ADDENDUM #6 RFB #25-0074 SEDGWICK COUNTY COURTHOUSE ANNEX REMODEL PHASE 2 - CORRECTIONS

5 Addendum Number Two

Sedgwick Co Courthouse Annex Remodel – Phase 2 - Corrections 525 N. Main Street WICHITA, KANSAS 67203

A22.1

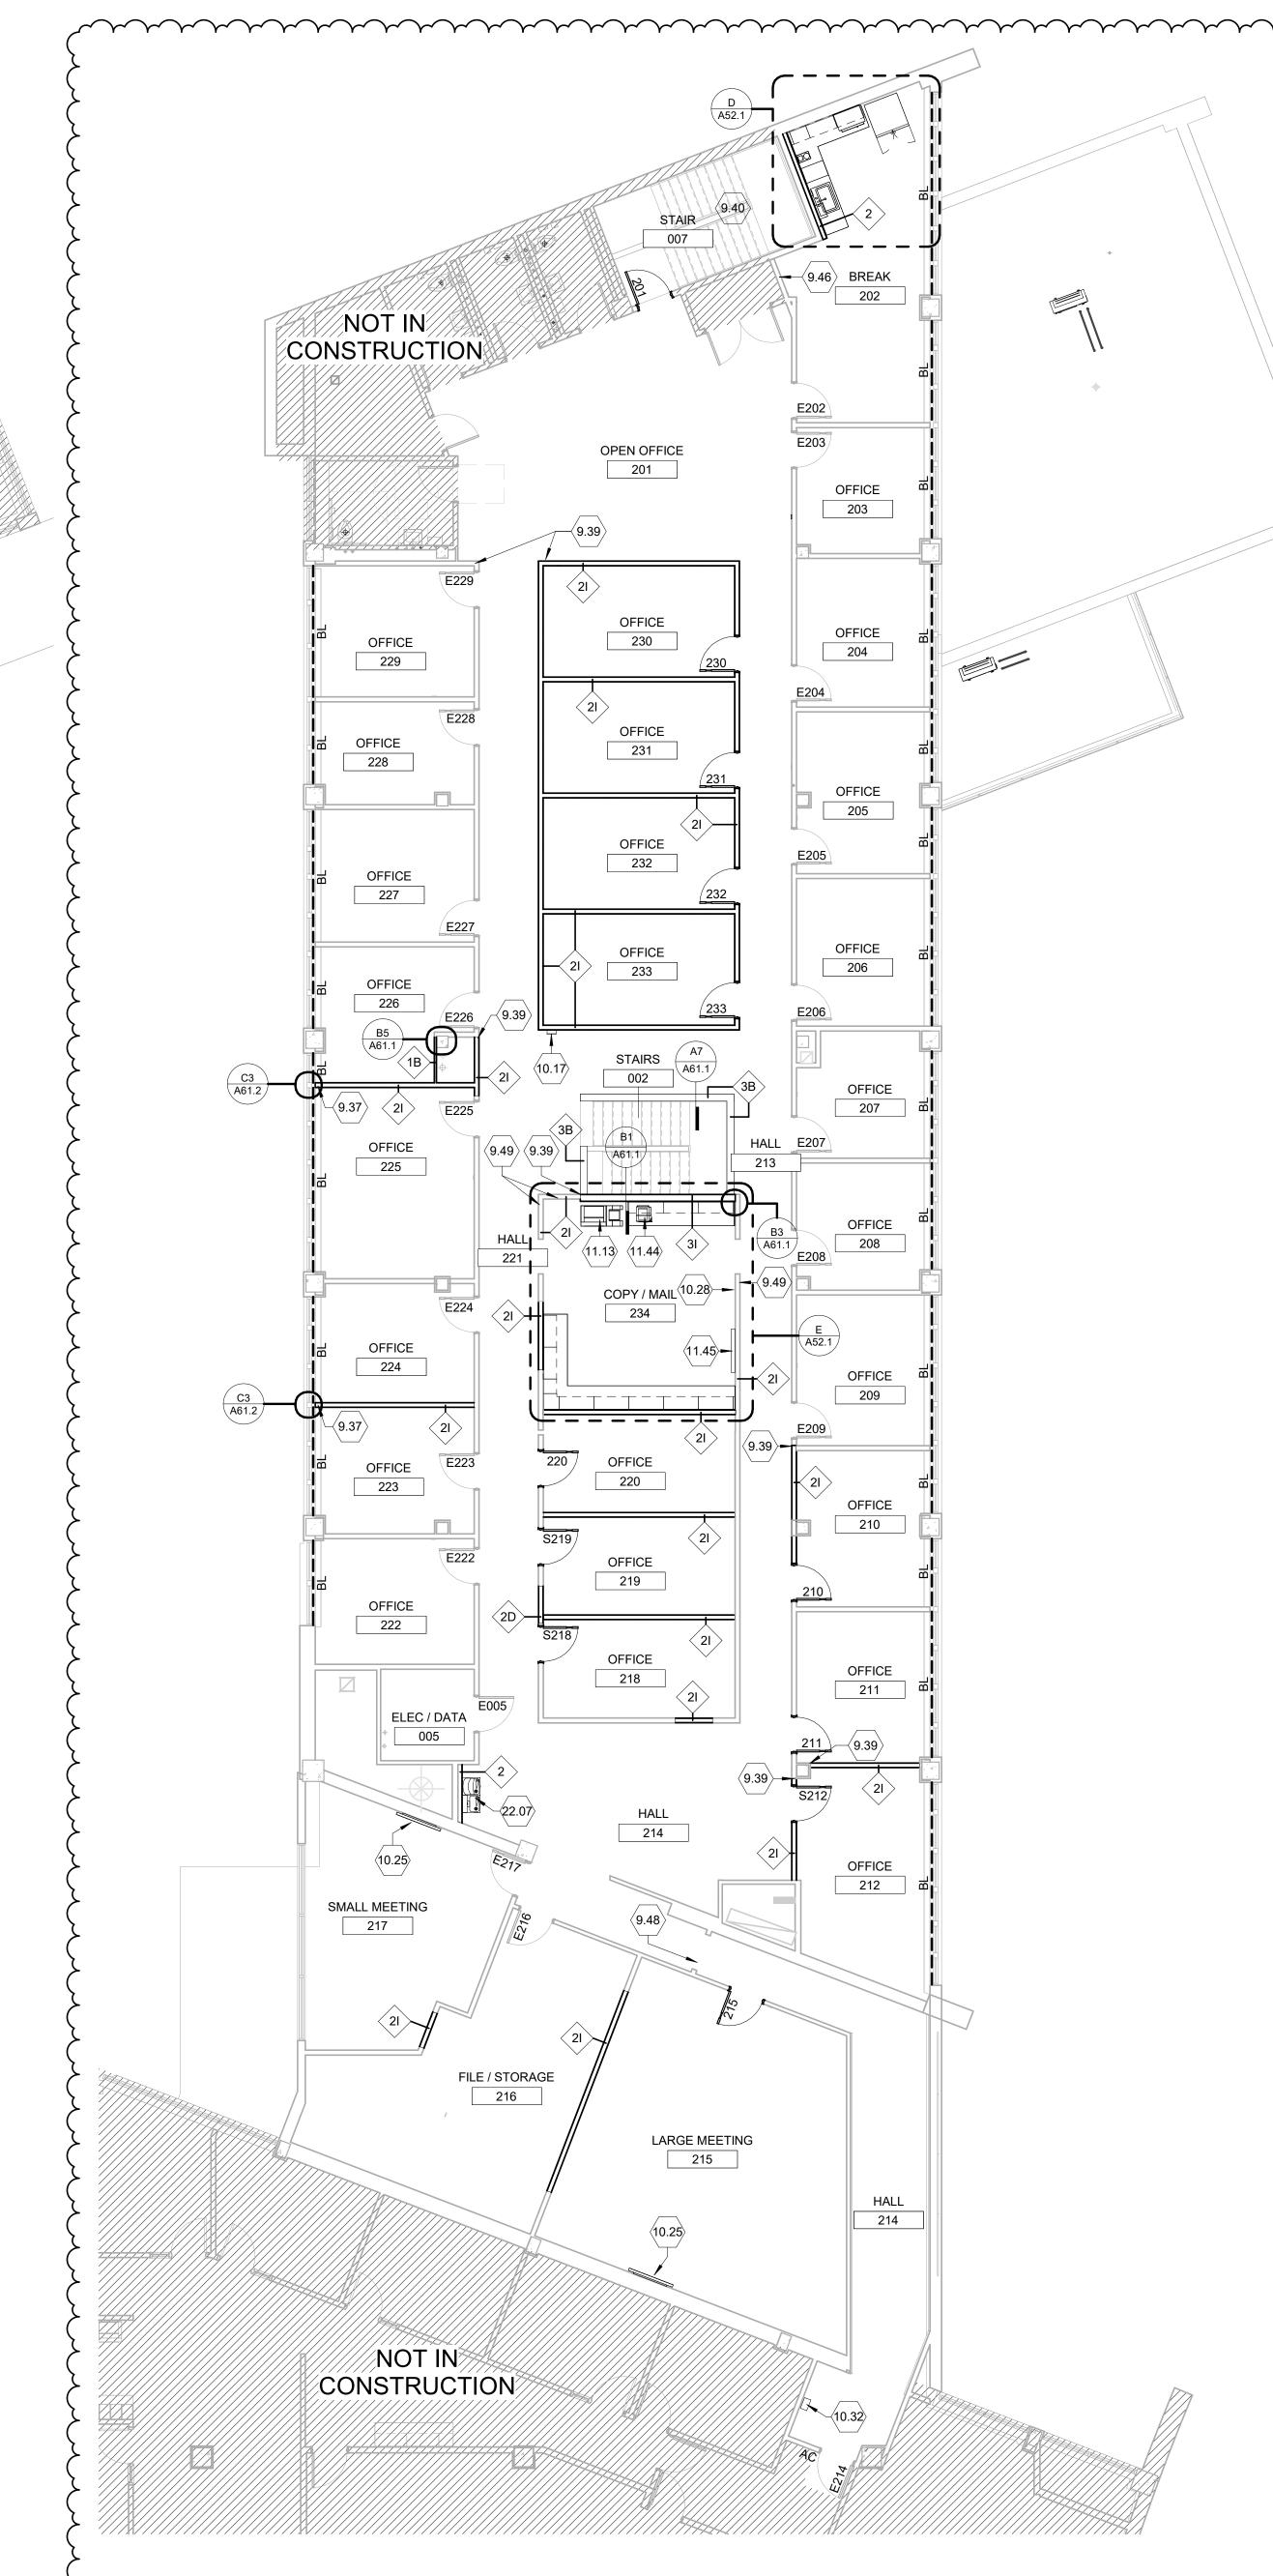
ITEM AD2-A01 Drawing Sheet A22.1:

ADDITION New blinds added to second floor rooms.
